SLIC-E / TSLIC-E**Subscriber Line Interface Circuit****PEF 4265 / PEF 4365, Version 2.1**

Preface

This document explains the differences between SLIC-E PEF 4265 V2.1 / TSLIC-E PEF 4365 V2.1 and the predecessor version V1.2 ([Chapter 1](#)). With the new version the evaluation boards SMART 4265 V1.2 or SMART 4365 V1.1 have to be slightly modified ([Chapter 2](#)).

Figure 1 Power Supply Diode Configuration for SLIC-E V2.1

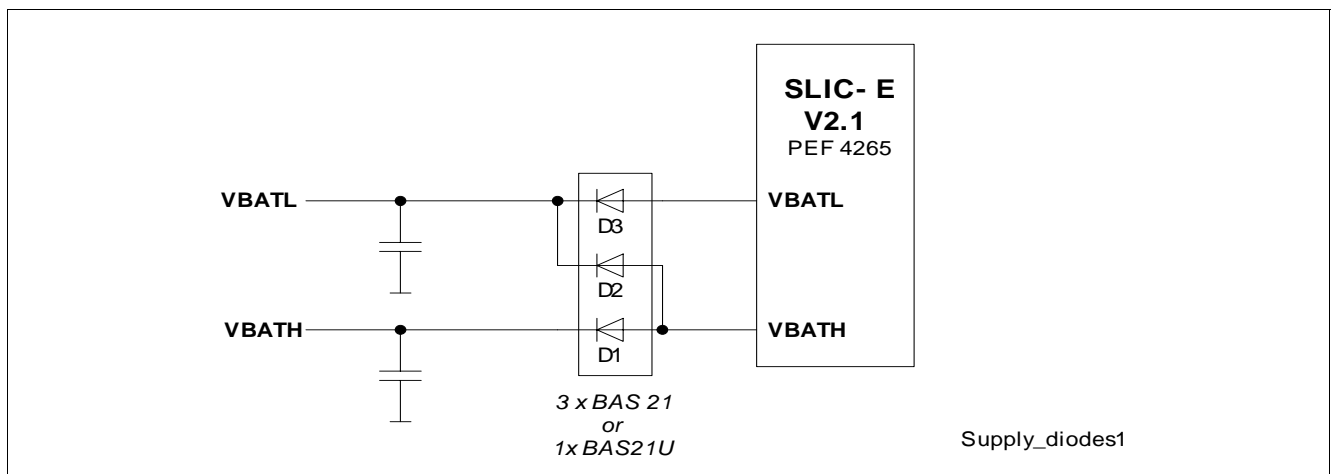
If two battery voltages are used, the diode scheme of [Figure 1](#) is required on a per channel base (with V1.2, sharing of D3 between different SLICs is allowed).

- Configurations where two or more SLIC devices share power supply diodes can not be used together with SLIC-E / TSLIC-E V2.1.

The recommended (and only valid) power supply diode configuration for SLIC-E V2.1 is shown in [Figure 1](#).

Figure 2 Power Supply Diode Configuration for TSLIC-E V2.1

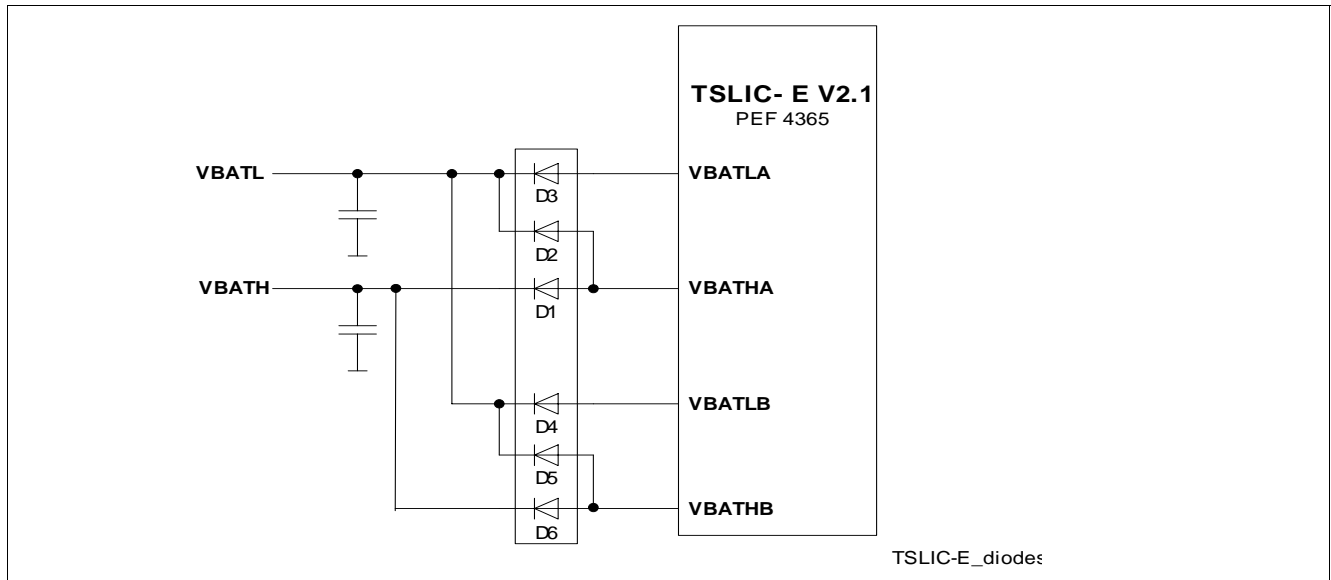
Similarly, the recommended (and only valid) power supply diode configuration for TSLIC-E V2.1 is shown in [Figure 2](#).

Figure 3 Location of C3 and C16 on SMART 4265 Version 1.2 (bottom side)

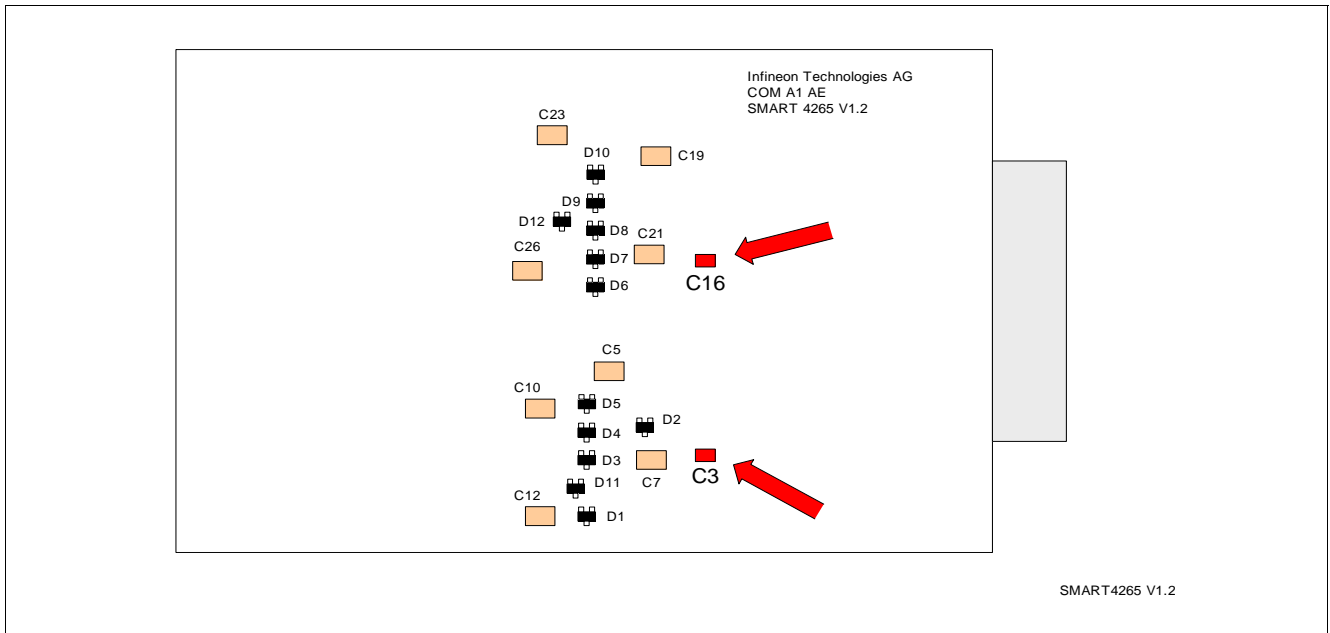
As mentioned in [Chapter 1.4.1](#), SLIC-E / TSLIC-E V2.1 requires a capacitor C_{EXT} with higher voltage rating and different nominal value compared to SLIC-E / TSLIC-E V1.2. As a consequence, SLIC-E / TSLIC-E V2.1 can not be used on the evaluation boards SMART 4265 V1.2 (PEF 4265) or SMART 4365 V1.1 (PEF 4365) without any modification. The capacitor C_{EXT} corresponds to capacitor **C3** (channel A) and to capacitor **C16** (channel B) on these boards. Both capacitors must be changed according to [Table 1](#). A SMD type of 0805 size is required. The locations of both capacitors are shown in [Figure 3](#) (SMART 4265 V1.2) and in [Figure 4](#) (SMART 4365 V1.1).
